METROPOLITAN GOVERNMENT OF NASHVILLE AND DAVIDSON COUNTY

STAFF RECOMMENDATION
415 North 15th Street
July 16th, 2014

Application: New construction—Detached accessory dwelling unit
District: Lockeland Springs-East End Neighborhood Conservation Zoning Overlay
Council District: 06
Map and Parcel Number: 08305043700
Applicant: Lynn Taylor
Project Lead: Melissa Baldock, melissa.baldock@nashville.gov

SITE PLAN

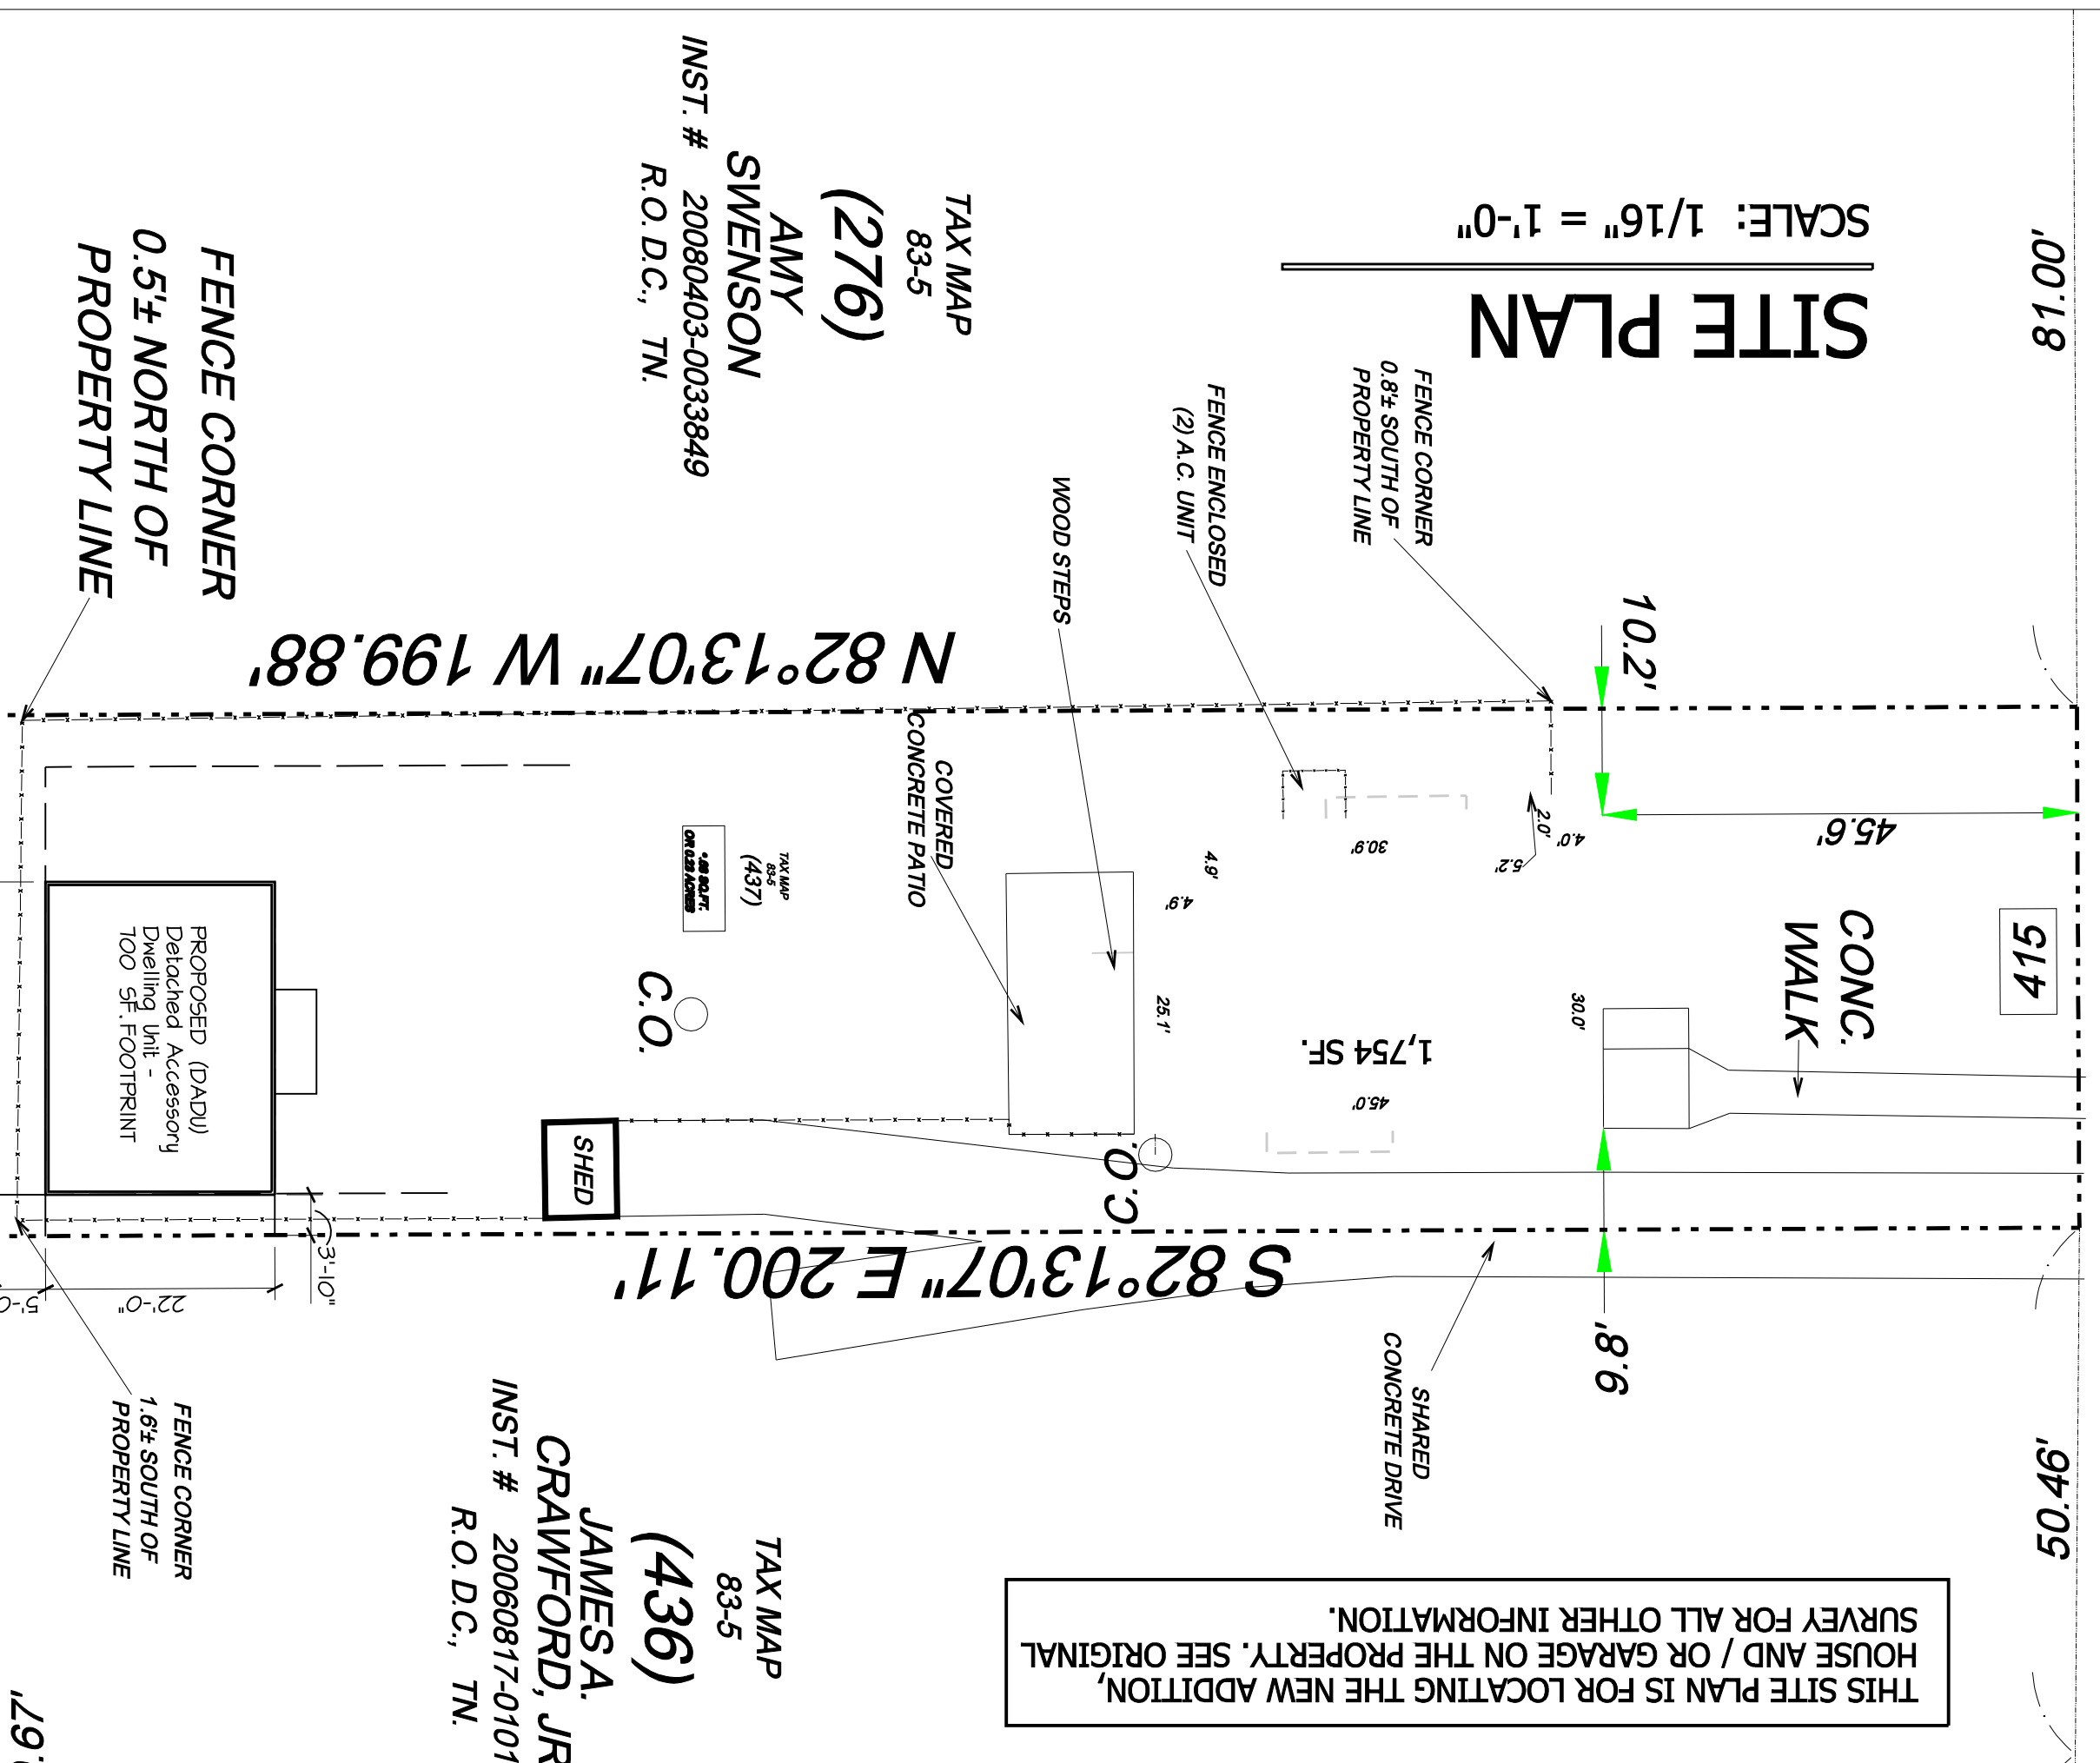
Setbacks. The proposed DADU meets all base zoning setbacks. Base zoning requires that the structure be three feet (3') from the rear and side property lines. The proposed DADU will be four feet (4') from the north side property line, five feet (5') from the rear property line, and sixteen feet (16') from south side property line. The structure therefore meets Standard 4 of the Detached Accessory Dwelling Unit regulations.

Site Requirements. The detached accessory dwelling unit is located in the rear yard of the primary structure at 415 North 15th Street. There will be approximately seventy feet (70') between the primary residence and the accessory structure. The structure therefore meets Standard 5 of the Detached Accessory Dwelling Unit regulations.

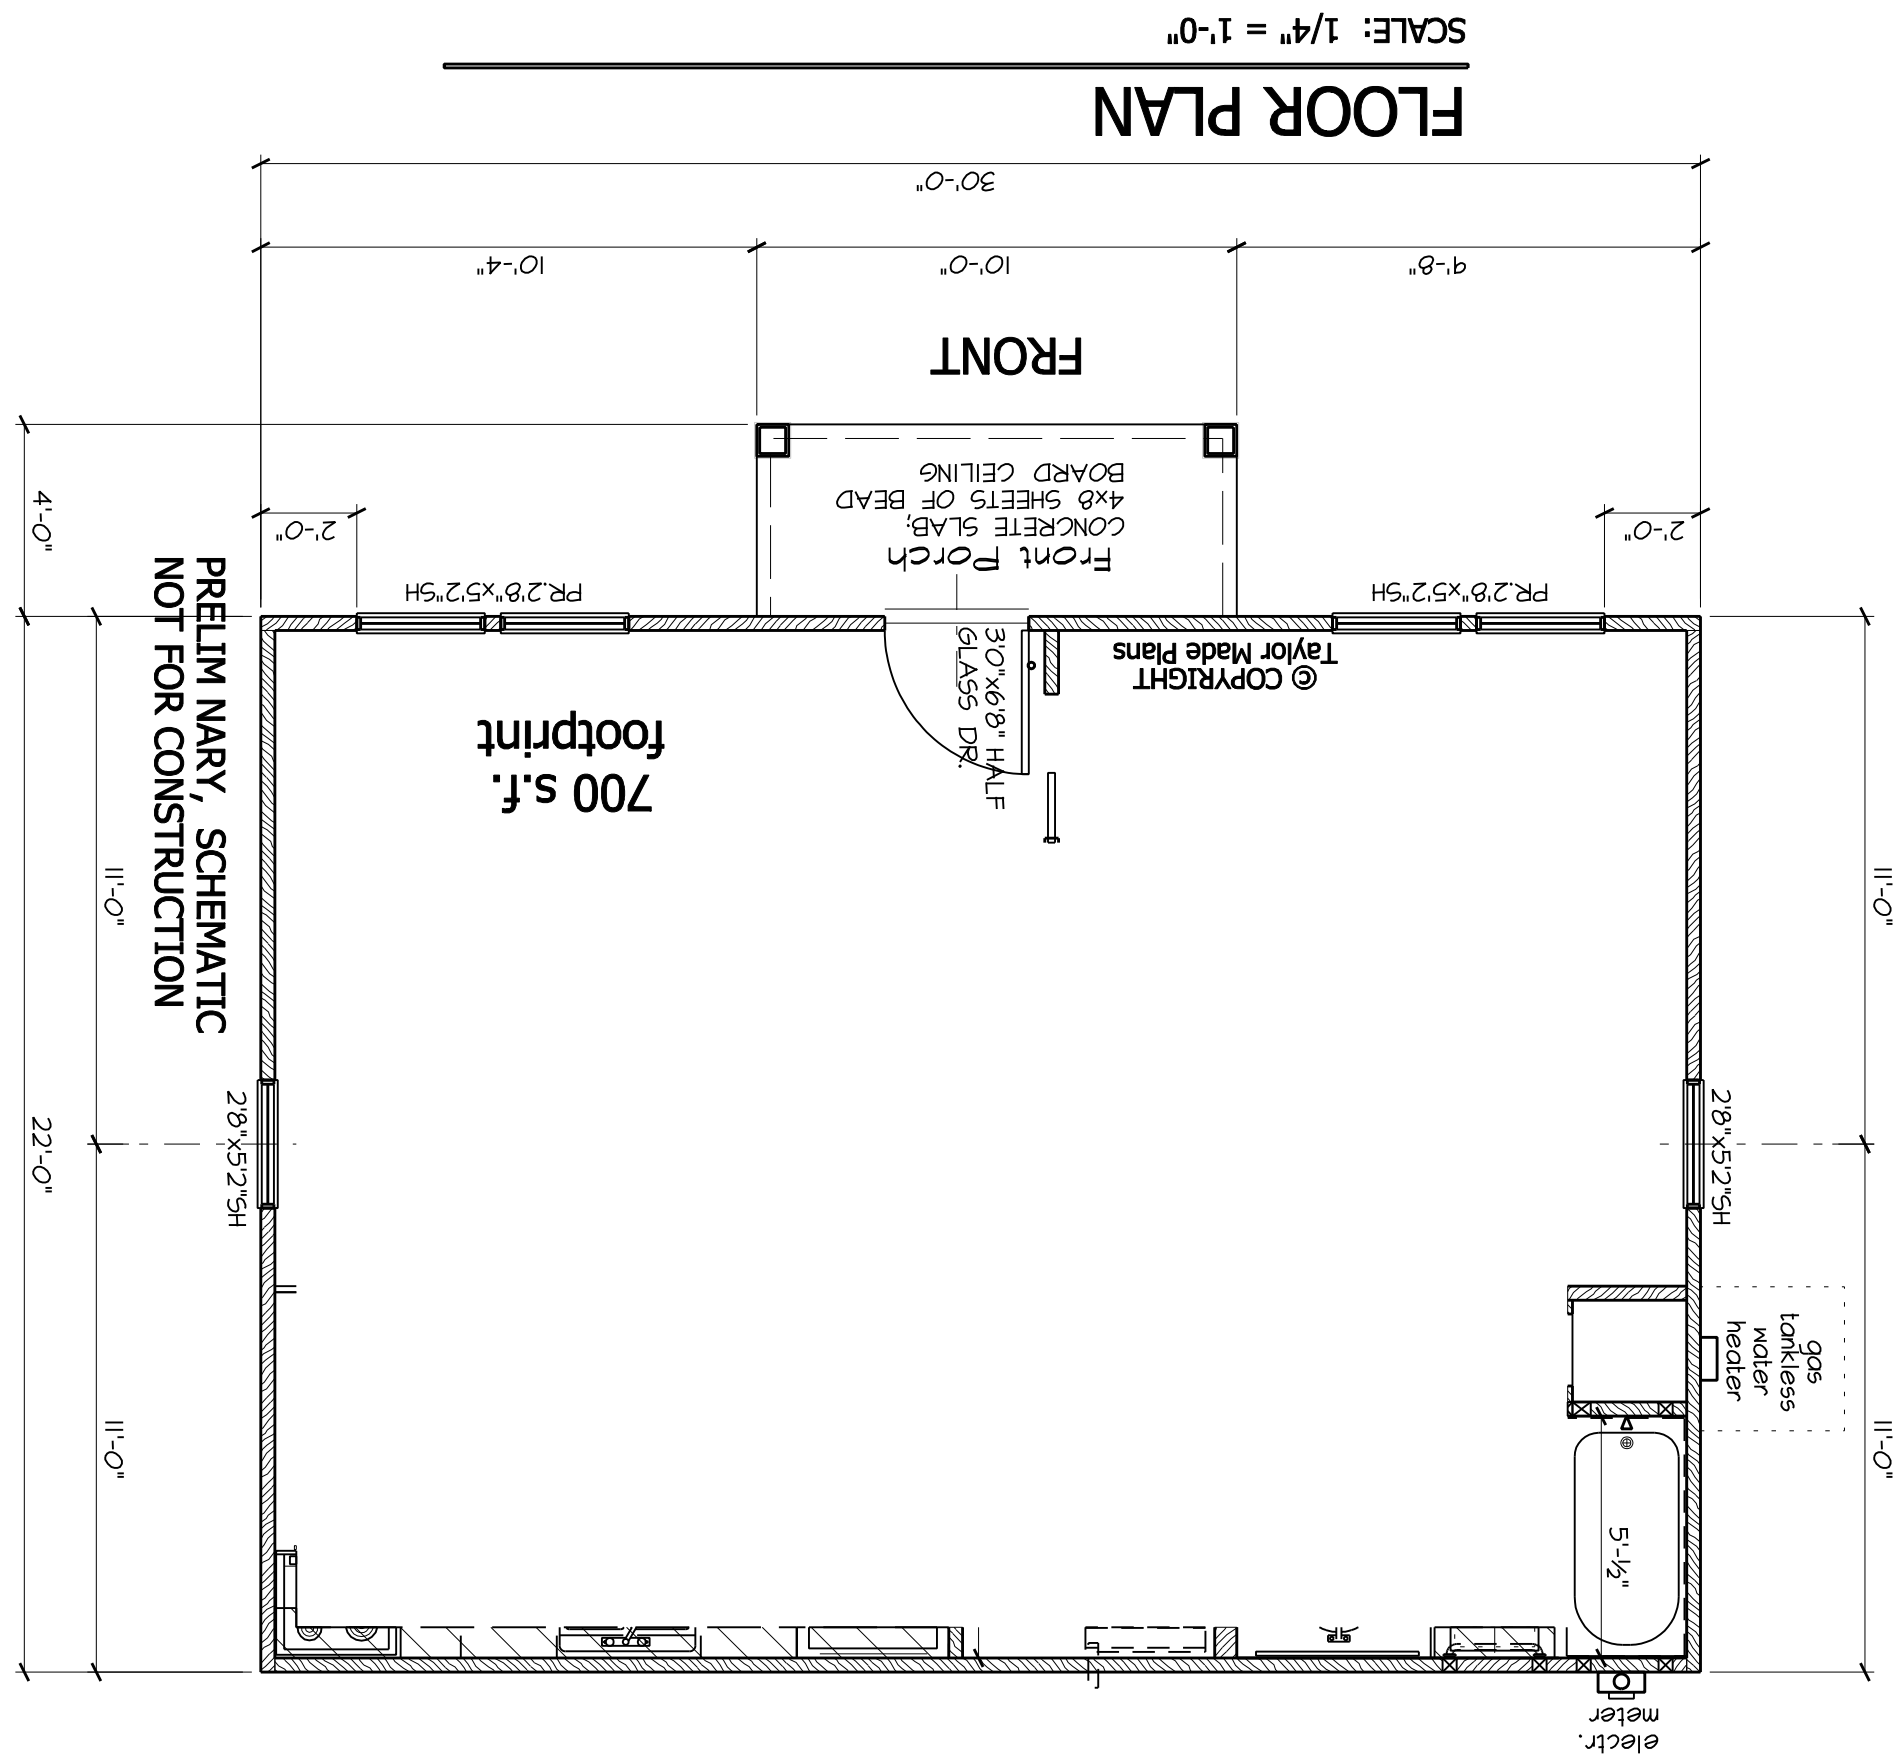
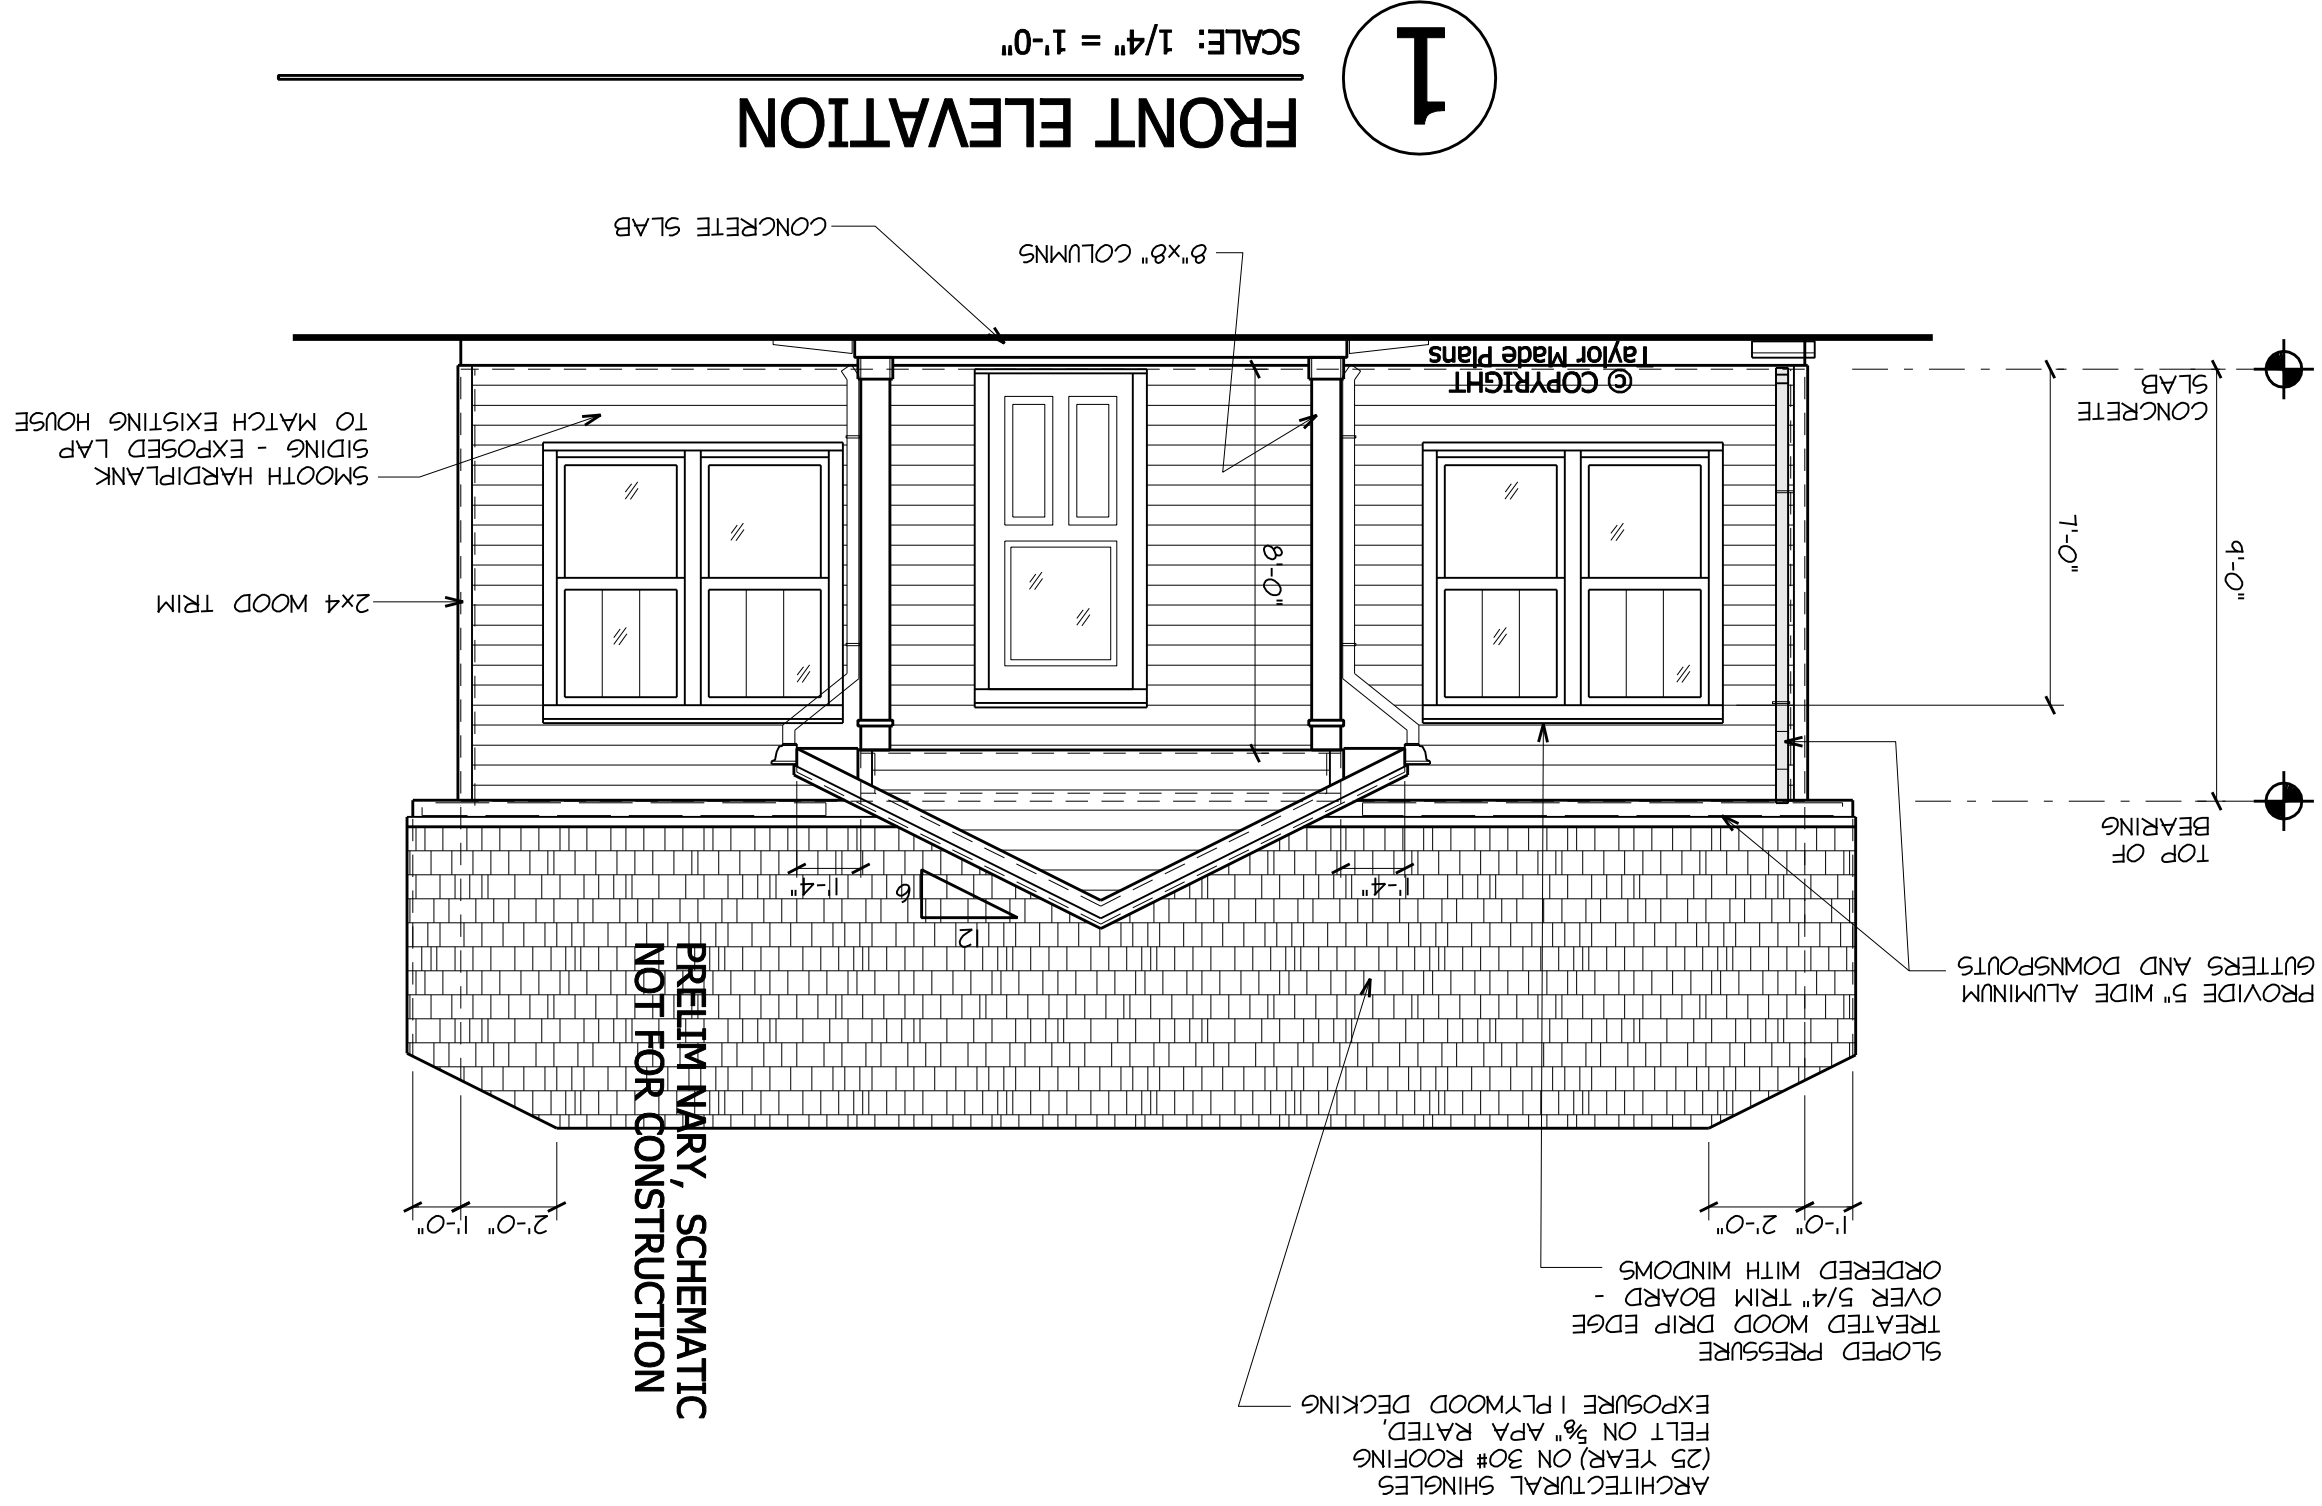
The structure's footprint is less than the maximum allowable footprint of seven hundred square feet (700 sq. ft.) for one-story DADUs, and it less than fifty-percent (50%) of the primary structure's footprint, which is over seventeen hundred square feet (1,700 sq. ft.). The DADU's eave height is approximately nine feet, six inches (9'6") and the ridge height is approximately sixteen feet, six inches (16'6"). These eave and ridge heights are subordinate to the historic house, which has an eave height of approximately eleven feet (11') and a ridge height of approximately twenty-two feet (22'), and are less than the maximums set by the DADU ordinance. The structure meets Standard 7 of the Detached Accessory Dwelling Unit regulations.

Design Standards. The DADU's design is compatible with the style of the historic structure. Its roof, detailing, and overall form do not contrast greatly with the primary structure. Because the existing structure is one-story, it does not include a stairway or dormers. The fenestration pattern is appropriate for an outbuilding. The proposed DADU therefore meet Standard 8 of the Detached Accessory Dwelling Unit regulations and II.B.8. of the design guidelines.

Materials: The DADU's foundation will be a concrete slab. The primary cladding material will be smooth-face Hardi plank with a reveal to match that of the historic house. The trim and porch will be wood. The roof will be architectural shingles, and staff asks to approve the shingle color. The materials for the windows and doors were not mentioned, and staff asks to approve all window and door specifications prior to purchase and installation. With the aforementioned staff approvals, staff finds that the materials meet section II.B.8. of the design guidelines.

Roof form: The proposed DADU will have a clipped gable roof with a slope of 6/12 which is similar to the historic house's roof form. Staff finds that the DADU's roof forms meet section II.B.8. of the design guidelines.

1. The owner file a restrictive covenant for the detached accessory dwelling unit prior to issuance of permit; and,
2. Staff approve the window and door specifications and the asphalt shingle color prior to purchase and installation of these materials.
